# MASSACHUSETTS GENERAL HOSPITAL

## AMBULATORY CARE CENTER FINAL ENVIRONMENTAL IMPACT REPORT

FINAL ENVIRONMENTAL IMPACT REPORT  
FOR THE  
MASSACHUSETTS GENERAL HOSPITAL  
AMBULATORY CARE CENTER

June 30, 1975

Figure VI-1

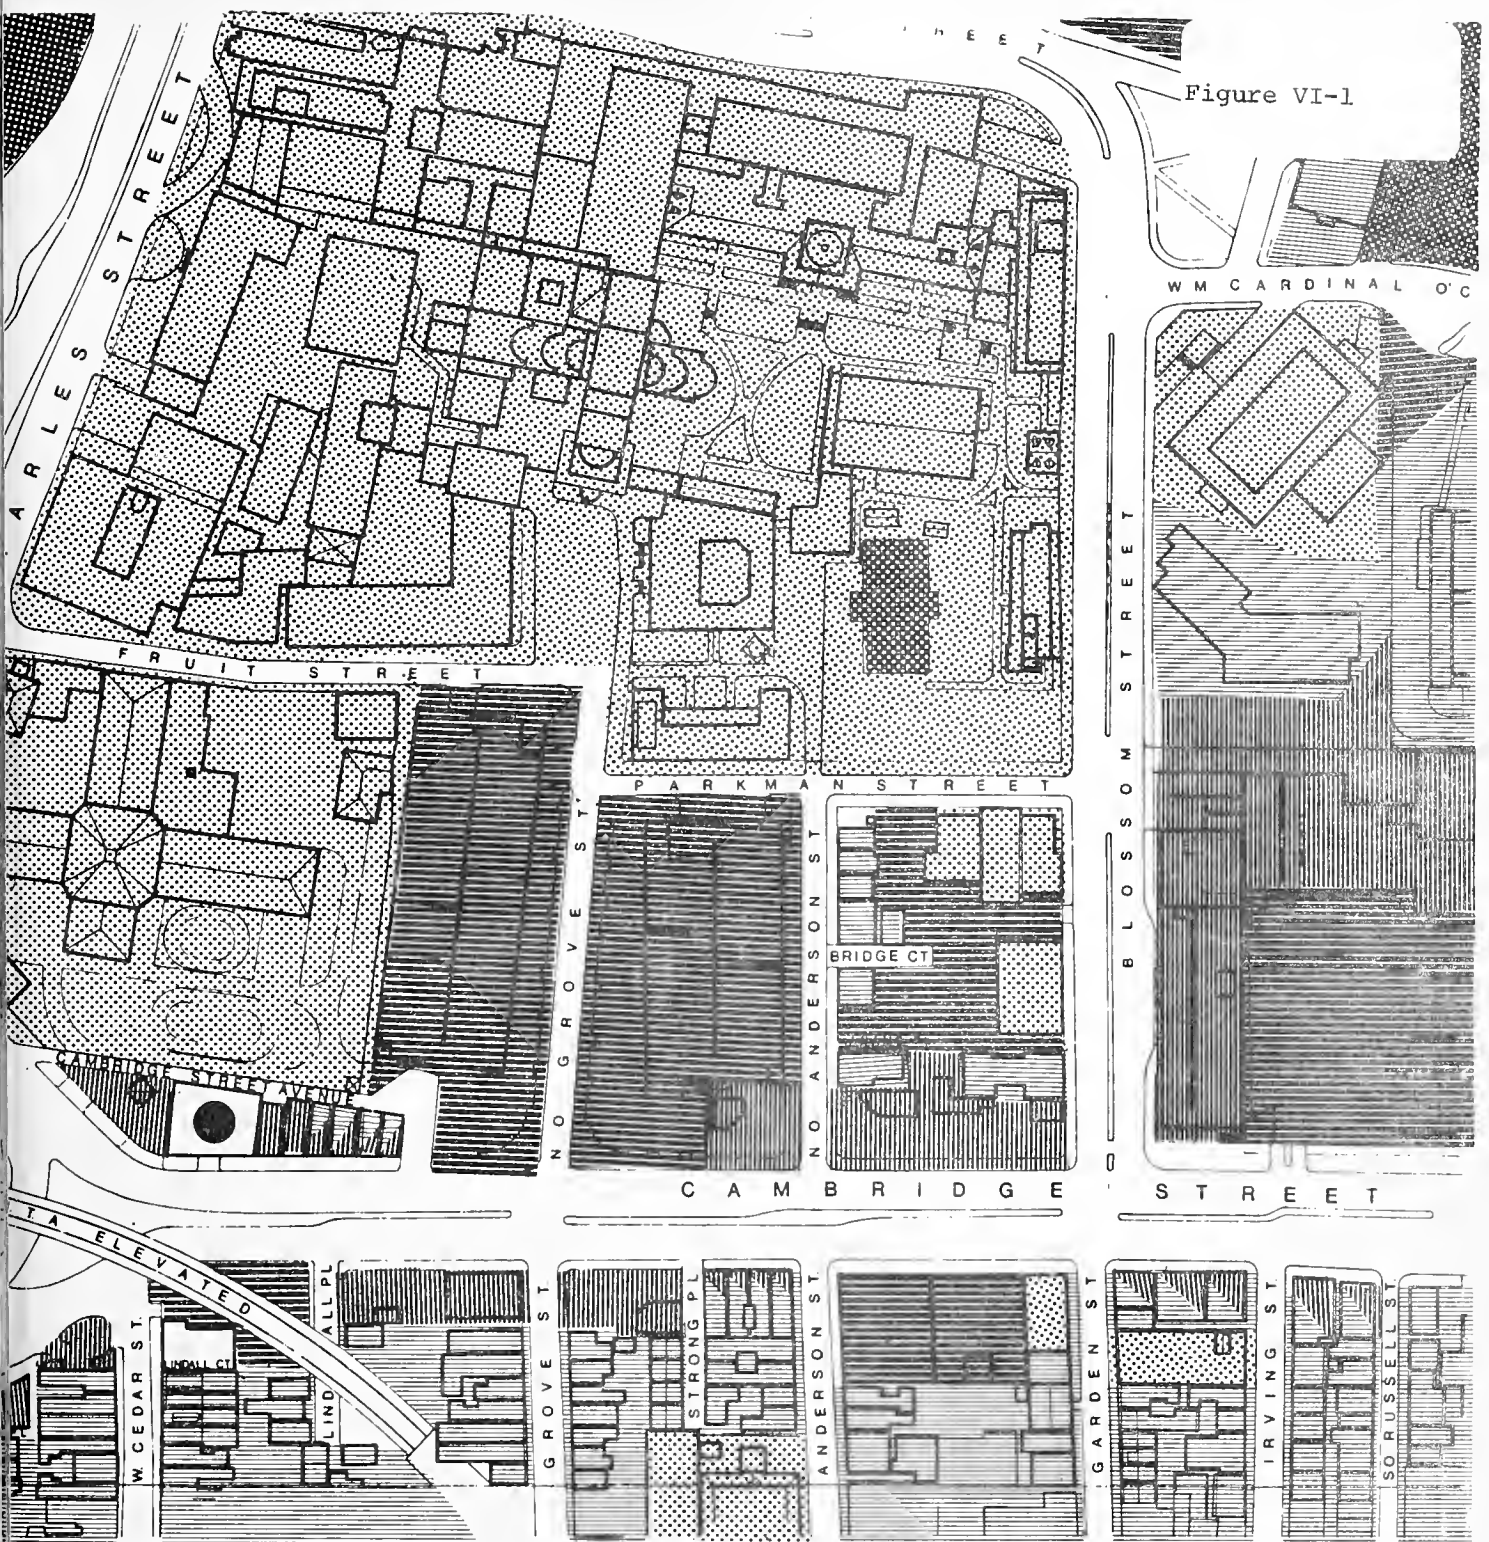
- p. VI-5                      7) One of the temporary buildings in the Bullfinch Courtyard is designated for recreation use in Figure VI-1, Existing Land Use. What activities are referred to and where will they be accommodated if the proposed project is constructed?
